Subject: MHI's Responses to NRC's Request for Additional Information Technical Report CFD Analysis for Advanced Accumulator MUAP-09025

**MHI's Responses to NRC's Request
for Additional Information**

**Technical Report CFD Analysis for Advanced Accumulator
MUAP-09025**

RAI for CFD Analyses for Advanced Accumulator, MUAP-09025-P (R0)

Figure 1-1 Boundary Pressure Setup Method in 1/2 scale Model

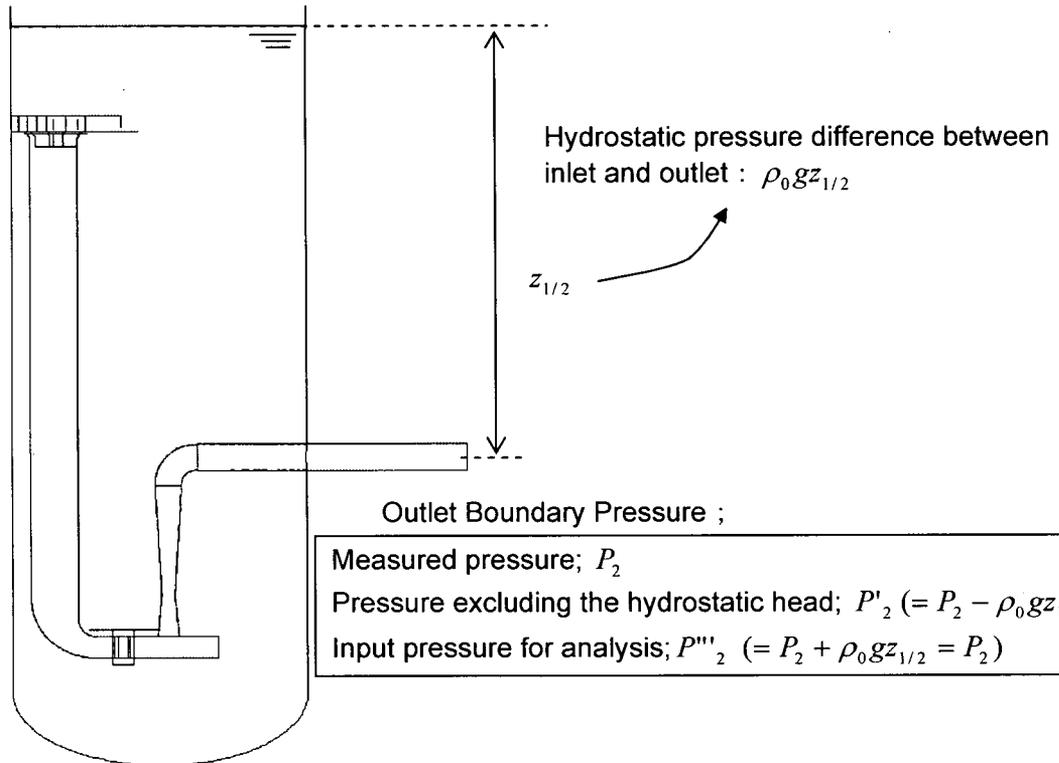
- c) In the boundary condition section (Sect. 3.4, Note 2) it is mentioned that the outlet

boundary conditions for the full scale is specified by subtracting the hydraulic pressure equivalent of height difference between the outlets for full scale and half scale facilities. For the 1/2 scale facility, the measured pressure is applied as outlet boundary condition without any correction.

- Please explain why this correction is needed for full scale facility calculations?
 - What are the differences in vertical dimensions of full scale and half scale facilities?
- d) Please show the difference in pressure values for the inlet and exit boundaries after the corrections were made for different cases.

In fact the outlet boundary condition in 1/1 scale model has been specified by using the measured pressure values in 1/2 scale test facility. Thus, Note 1 and Note 2 in Section 3.4 should be modified as follows.

(note1) An Inlet boundary pressure at tank side is corrected as follows.

The correction pressure value equivalent to a water-level difference between the height of water surface and the height of outlet pipe center is added to the measured inlet boundary pressure, i.e. tank pressure. This is because "Gravity Term" is included into Pressure Term in the calculation.

Here the inlet boundary pressure in the 1/1 scale model has been specified by utilizing the same pressure value in the 1/2 scale model. However, due to the fact that outlet pipe elevation in the 1/1 scale model is higher than that in the 1/2 scale model, hydraulic head caused by the elevation difference between the tank water surface and the center of outlet pipe in 1/2 scale model is different than that in the 1/1 scale model. Thus, proper corrections should be made in order to match the inlet/outlet differential pressure in the 1/2 scale model.

*(note2) An outlet boundary pressure is corrected as follows.
The reference pressure location has been specified at the outlet pipe. Thus, measured pressure data have been utilized as the outlet boundary pressure without correction.
Same corrected pressure measurement data have been applied in the 1/1 scale model.*

The outlet pipe elevation in the 1/1 scale model is higher than that in the 1/2 scale model. Hydraulic head caused by the elevation difference between the tank water surface and the center of outlet pipe in 1/2 scale model is different than that in the 1/1 scale model. Thus, same boundary pressure values as that in the 1/2 scale model have been specified in the 1/1 scale model in order to match the inlet/outlet differential pressure (which is the driving force of the flow) in the 1/2 scale model. Figure 1-1 explains this in detail.

The height of standpipe in 1/2 scale model is same as that in the 1/1 scale model. However, the elevation of outlet pipe in the 1/1 scale model is twice of that in the 1/2 scale model. From the top of vortex chamber, the elevation of outlet pipe in the 1/1 scale model is [] m, while the elevation of outlet pipe in the 1/2 scale model is [] m.

Inlet Boundary Pressure:

Measured pressure; P_1
 Pressure excluding the hydrostatic head; $P'_1 (= P_1)$
 Input pressure for analysis; $P''_1 (= P'_1 + \rho_0 g z_{1/2})$

Note: Since "Gravity Term" is included into Pressure Term in the calculation, same inlet/outlet boundary pressure values as that in the 1/2 scale model have been specified in the 1/1 scale model
